RECREATIONAL VEHICLE CUSTOMER SATISFACTION

Customer Satisfaction Campaign:

CSC-260814

CUSTOMER SATISFACTION CAMPAIGN

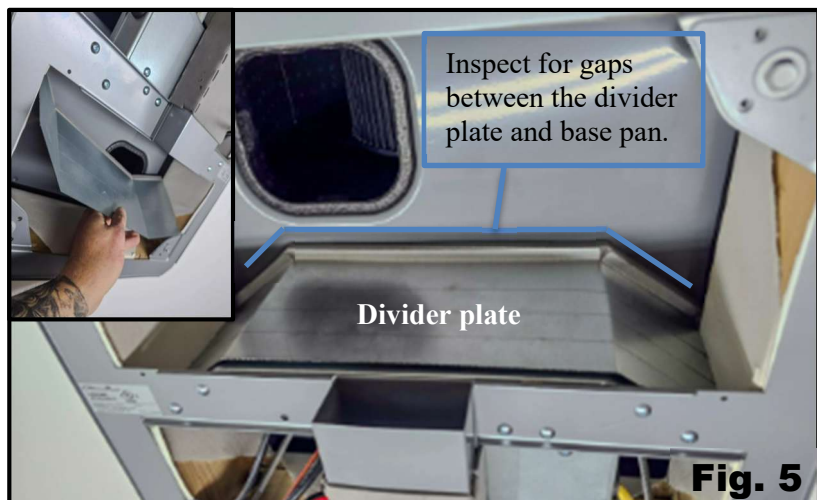
The remedy is to remove the A/C ceiling shroud and inspect for the presence of a plenum duct plate. If present, remove the plenum duct plate and inspect the divider plate. Ensure the divider plate is properly positioned and seated firmly against the A/C base pan.

- 1.) Remove the Coleman-Mach A/C ceiling shroud vent by pushing upward on the vent to release the retaining latch. Once released, pull the vent downward at an angle to remove it from the ceiling shroud. See Fig. 1 – Fig. 2
- 2.) Use a screwdriver to remove the four screws securing the A/C shroud to the ceiling mounting frame. See Fig. 3

- 3.) Use a screwdriver to remove the four screws securing the plenum duct plate to the ceiling mounting frame. Inspect the divider plate for any gaps, ensure that the divider plate is seated firmly against the base pan of the A/C, adjust if needed. See Fig. 4 – Fig. 5

- 4.) Reinstall the Coleman Mach A/C ceiling shroud to the ceiling mounting frame using the four screws previously removed and then reinsert the ceiling shroud vent as shown in Fig.1.
